**July 17, 2024**

### **COYOTE BOOSTER PUMP STATION PUMP CAN REPLACEMENT PROJECT NO. 53002**

#### **ADDENDUM NO. 1**

NTS

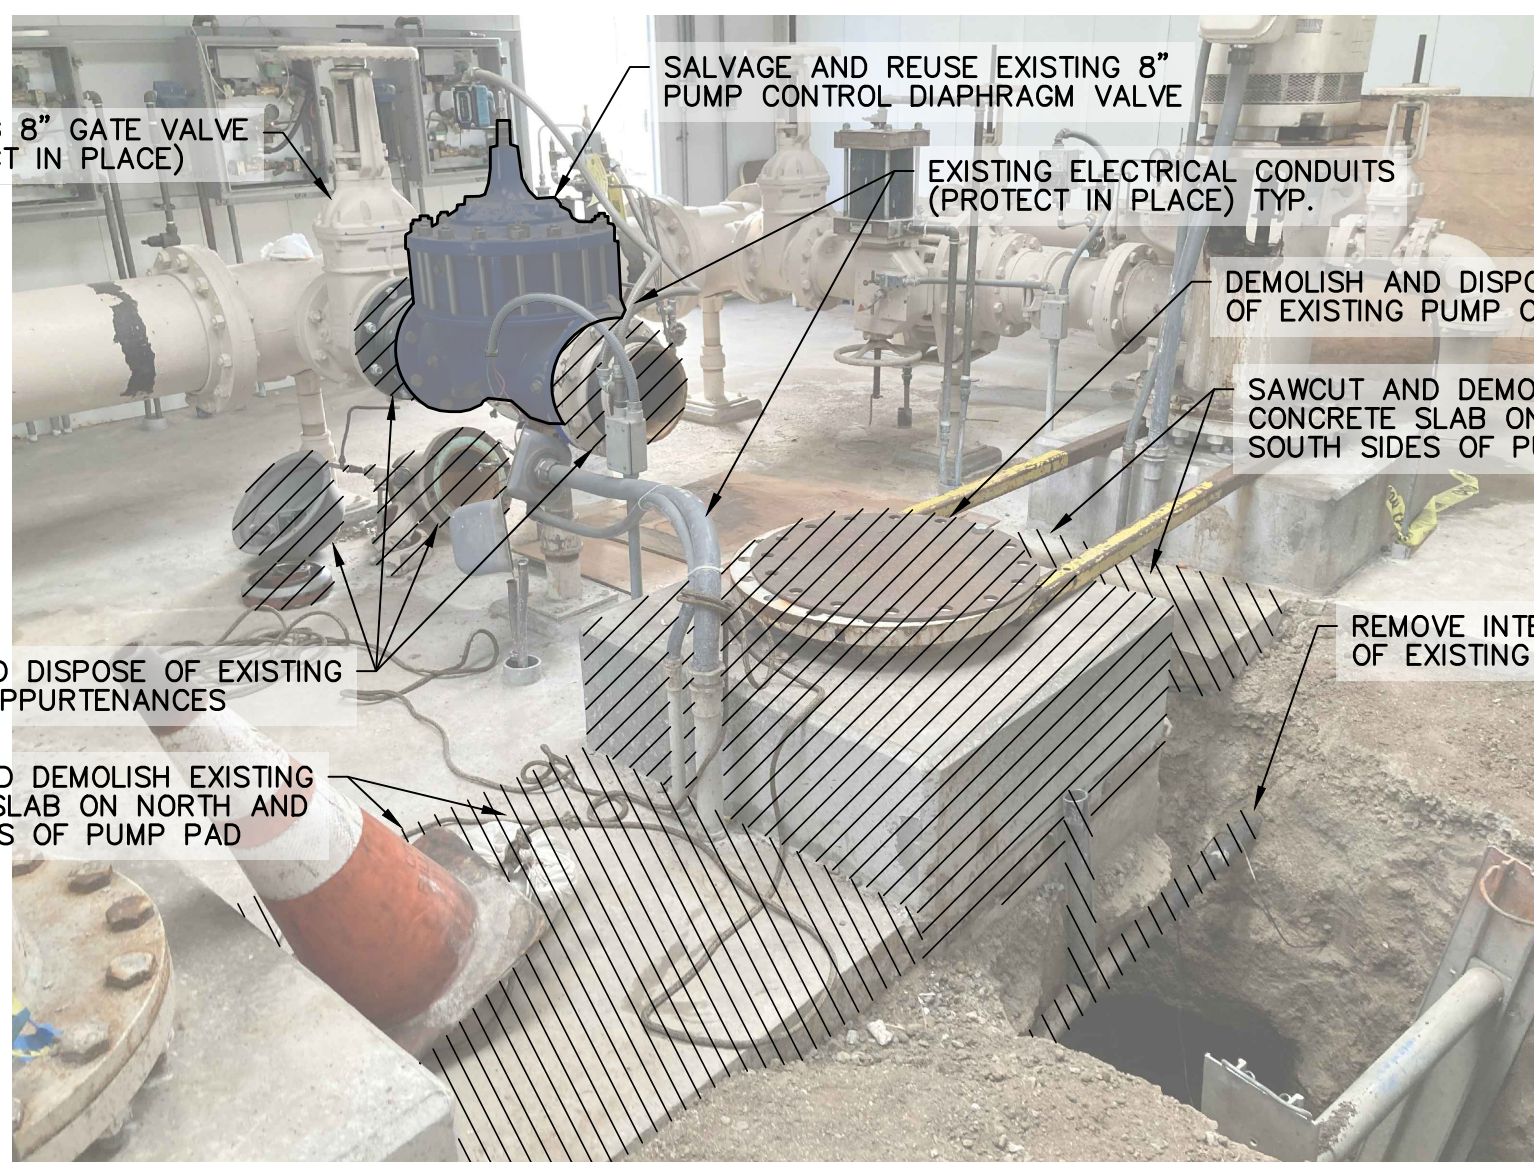
**Sheet 2 of 4 – Site and Demolition Plan**

REMOVE and REPLACE with revised Sheet 2 of 4 (attached).

- NOTE:**
1. CONTRACTOR TO DEMOLISH EXISTING CONCRETE PUMP PAD PRIOR TO REMOVING CONCRETE ENCASED PUMP CAN THROUGH OPENING OF EXISTING SKYLIGHT.
  2. CONCRETE ENCASEMENT MAY NEED TO BE JACK HAMMERED TO SIZE TO REMOVE PUMP CAN THROUGH EXISTING OPENING.

COYOTE BOOSTER PUMP STATION - PUMP CAN REPLACEMENT  
CIP PROJECT 53002  
**WATER IMPROVEMENTS**  
**COYOTE BOOSTER PUMP STATION PUMP CAN REPLACEMENT**  
MECHANICAL PLAN, SECTION, & DETAILS

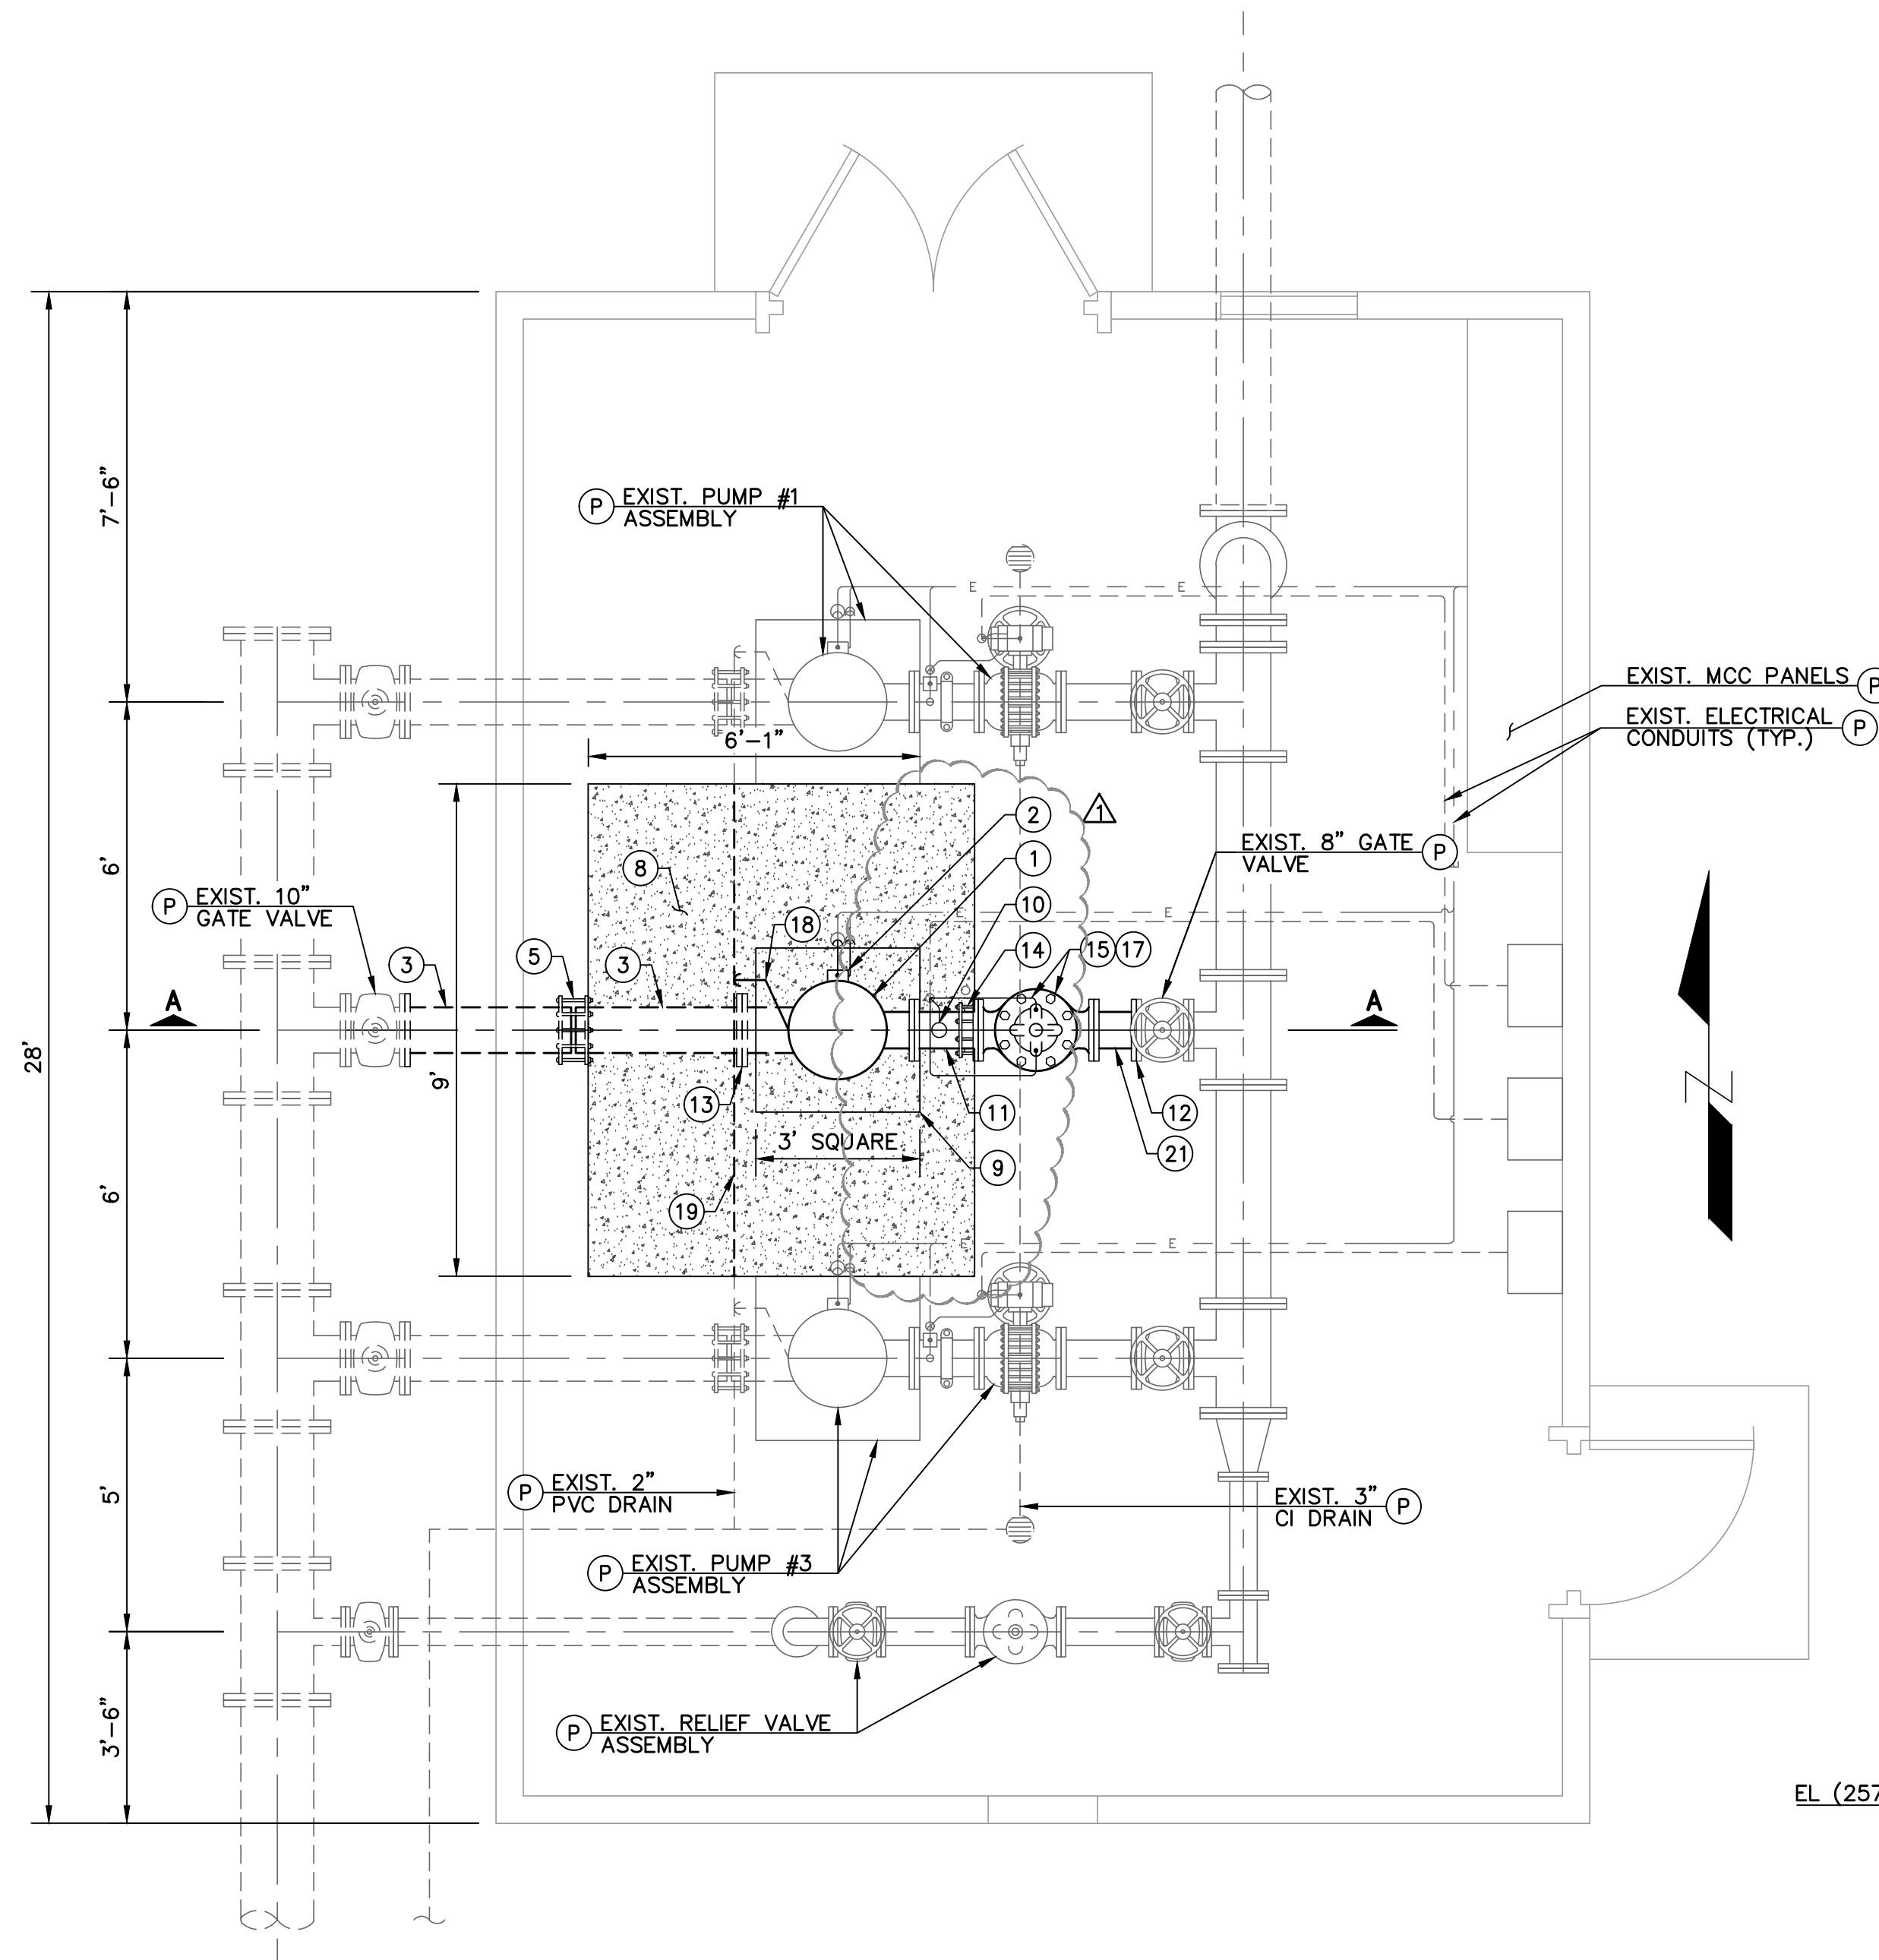
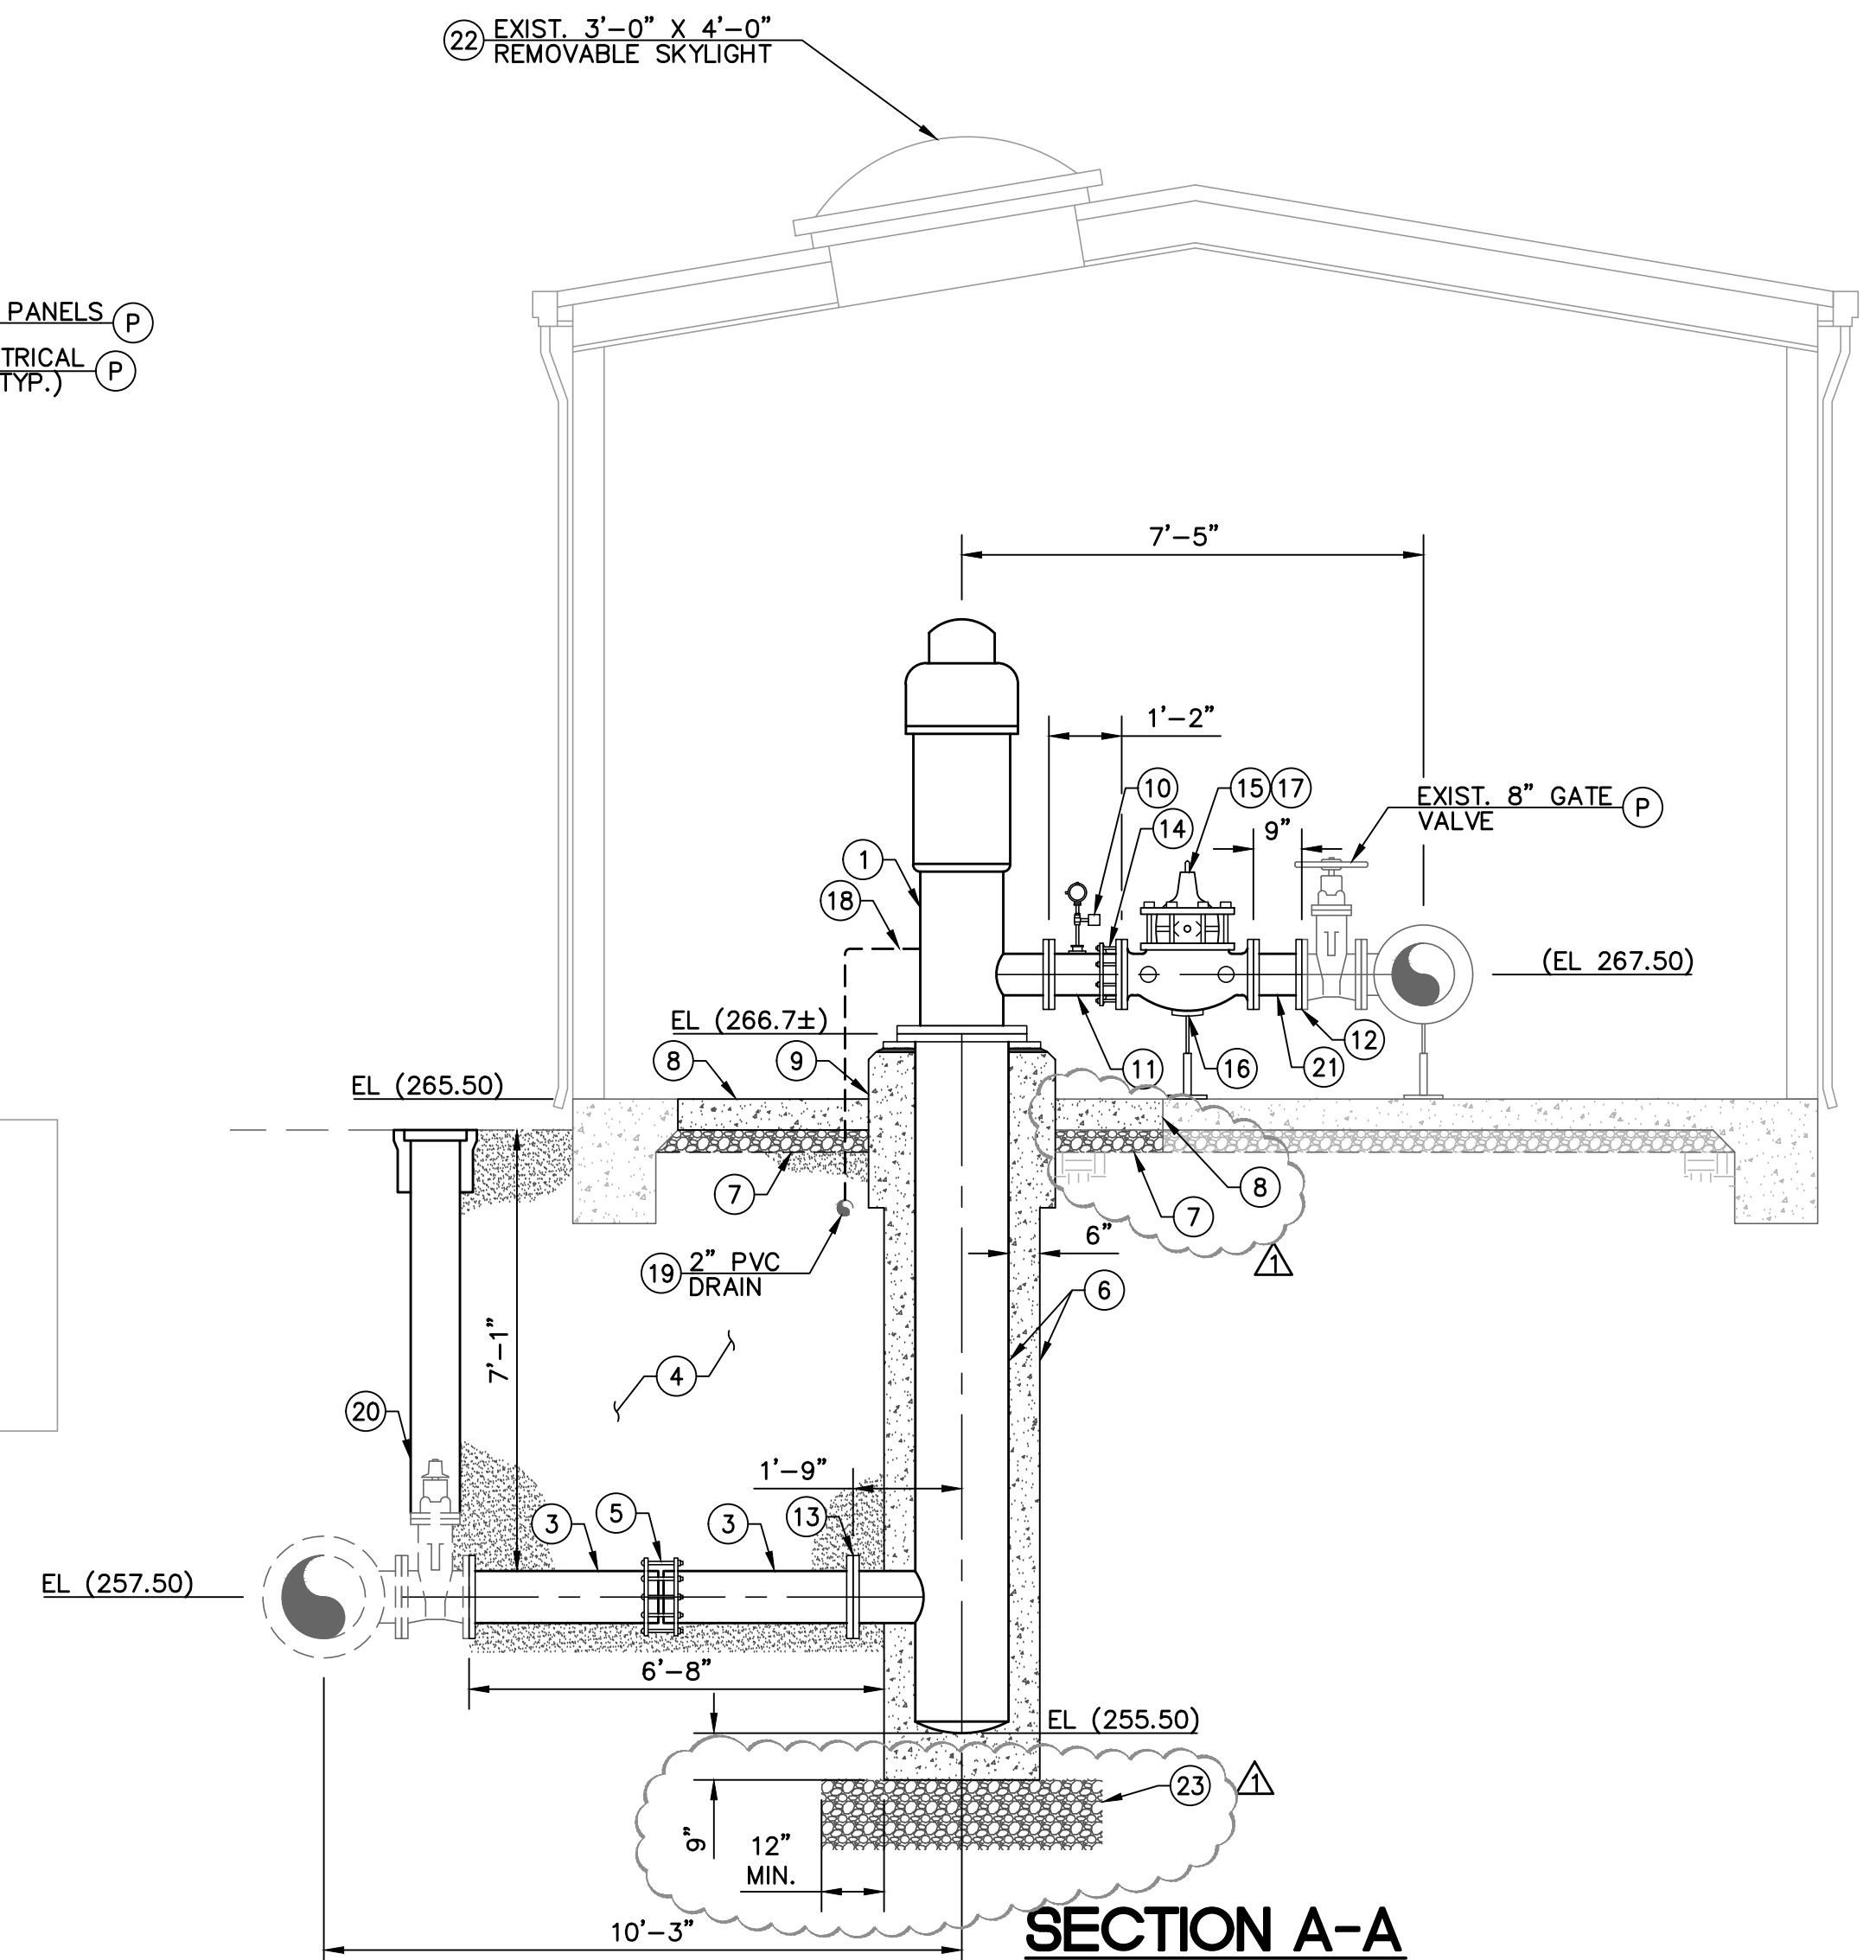
**Sheet 3 of 4 – Mechanical Plan, Section, & Details**

REMOVE and REPLACE with revised Sheet 3 of 4 (attached).

1. RECONDITIONED PUMP AND MOTOR ASSEMBLY IS STORED AT PROJECT SITE.
2. PROTECT IN PLACE AND SUPPORT EXISTING CONDUITS AND CONDUCTORS DURING DEMOLITION AND RECONSTRUCTION OF CONCRETE SLABS.
